# Access Compliance Report

## Public Rights-of-Way

### (Curb Ramps)

Intersection ID: N/A	Main Street: INVERNESS_BAY_RD	Cross Street: DALLAS_BAY_RD	Location: SW
ADA ID: 97DF20834C66	Ramp Type: PerpDiag	Initial Pass/Fail: Fail	Overall Compliance: No
		Severity Score: 12.5

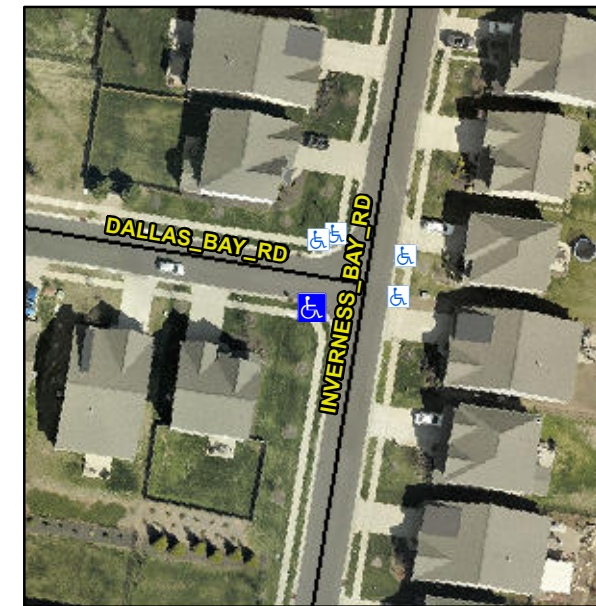
**R304.2.2**

Compliance	Description	Data	Compliance	Description	Data
N/A	Ramp Length (in)	47.5	No	Ramp Slope (%)	10.9
Yes	Ramp Width (in)	48.0	Yes	Ramp XSlope (%)	1.8
N/A	Flare Type LT	N/A	N/A	Flare Type RT	N/A
N/A	Flare Slope LT (%)	N/A	N/A	Flare Slope RT (%)	N/A
N/A	Flare Traversable LT?	N/A	N/A	Flare Traversable RT?	N/A
N/A	Landing Length (in)	N/A	N/A	DWS Provided?	N/A
N/A	Landing Width (in)	N/A	N/A	DWS Contrast?	N/A
N/A	Landing Slope (%)	N/A	N/A	DWS Length (in)	N/A
N/A	Landing X Slope (%)	N/A	N/A	DWS Full Width?	N/A
N/A	Landing Curb? (Y/N)	N/A	N/A	DWS Offset (in)	N/A
N/A	Shared Landing?	N/A			
N/A	Gutter Ponding?	N/A	N/A	Gutter Slope (%)	N/A
N/A	Gutter Lip Ht (in)	1.0	N/A	Gutter X Slope (%)	N/A
N/A	Painted X Walk1?	No	N/A	Painted X Walk2?	No
	X Walk 1 Direction	To SE		X Walk 2 Direction	To NE
N/A	X Walk 1 Width (in)	N/A	N/A	X Walk 2 Width (in)	N/A
	X Walk 1 Slope (%)	2.6		X Walk 2 Slope (%)	2.5
	X Walk 1 X Slope (%)	3.1		X Walk 2 X Slope (%)	0.5

**Remove & Replace Curb Ramp With Two New Directional Ramps or Equivalent.**
